Staff Report

То:	Planning Commission
Through:	Chris Kerr, AICP, Community Development Director \mathcal{CK}_{ℓ}
From:	Colin Cortes, AICP, CNU-A, Senior Planner
Meeting Date:	June 23, 2022 (Prepared June 15, 2022)
Item:	"Marion Pointe" Planned Unit Development (ANX 22-02)
Tax Lot(s):	051W06D000502 (primary), 500, & 800 and 051W06DC00201 & 300 (no address; Boones Ferry Rd NE east side north of Hazelnut Dr)
Table of Conte	nts HE PLANNING COMMISSION1
	MARY2
RECOMMENDAT	ION4
CONDITIONS OF	APPROVAL4
ACTIONS	
ATTACHMENT LI	ST13
In the form the

Annexation ANX 22-02 (Type IV) with proposed planned unit development PUD 22-02 Marion Pointe: Commission is to hold a public hearing and make a recommendation to the City Council.

Exhibit PUD-3f: Site Plan Sheet P-26 Sidewalks (blue: min 8 ft wide); see Attachment 103 for full size

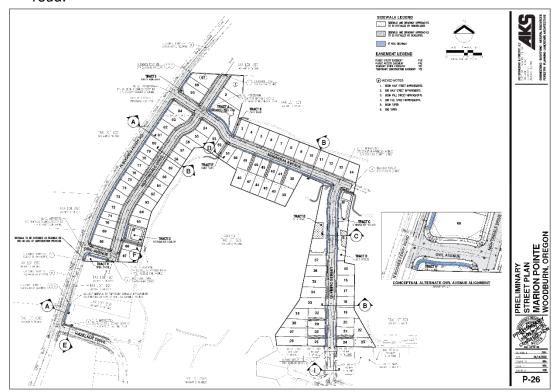
- f. Sidewalks: Min 6 ft wide except wider as Exhibit PUD-3f supersedes. BFR sidewalk southerly and two northerly dead-ends shall have ADA-compliant transitions spanning between sidewalk and road shoulder as the applicable public works authority specifies. The segment extending north from Hazelnut sidewalk may meander, including PUE overlap, and taper to 6 ft through RPZs to save most of the loose row of trees along the road.

Top: Figure 3.01C - Minor Arterial (This applies to N. Boones Ferry Road.)

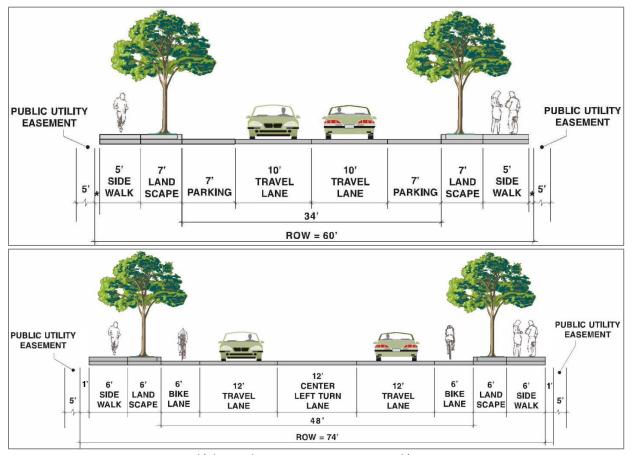
- a. BFR: Per WDO Fig. 3.01C except that planter strip shall be min 6½ ft wide inc. curb width.
- b. Olympic: Bridge or culvert crossing over Mill Creek tributary: Per WDO 3.01.03H through Ordinance No. 2603 (LA 21-02) adopted June 13, 2022, and:
 - (1) Elevation: Shall be such that the travel way and parking lanes wouldn't flood during the 100-year flood.
 - (2) Sidewalks: min width 9 ft inc. curbing.
 - (3) Fencing/railings: Permissible colors are blue, bronze, brown, green, teal, metal, and rust color. (Black prohibited.)
 - (4) Design details are deferred to PUD Final Plan Approval process; refer to Condition PUD-11.
- c. Tract D: The developer shall grant to the City over the entire tract a public street easement. The easement shall allow for all purposes permitted by what would have

Bottom: Figure 3.01G - Local Residential Street with Parking Both Sides, 60 Foot Right-of-Way (This applies to remaining streets.)

Exhibit PUD-3f: Site Plan Sheet P-26 Sidewalks (blue: min 8 ft wide); see Attachment 103 for full size

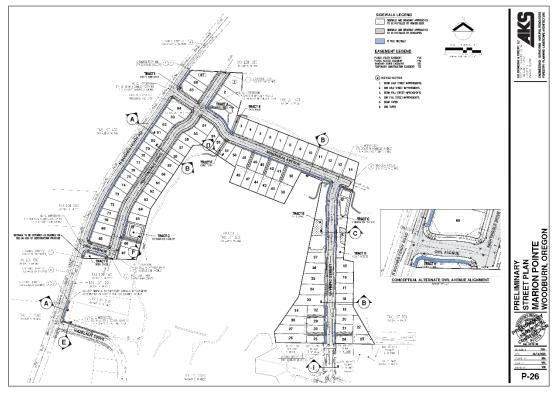
- f. Sidewalks: Min 6 ft wide except wider as Exhibit PUD-3f supersedes. BFR sidewalk southerly and two northerly dead-ends shall have ADA-compliant transitions spanning between sidewalk and road shoulder as the applicable public works authority specifies. The segment extending north from Hazelnut sidewalk may meander, including PUE overlap, and taper to 6 ft through RPZs to save most of the loose row of trees along the road.
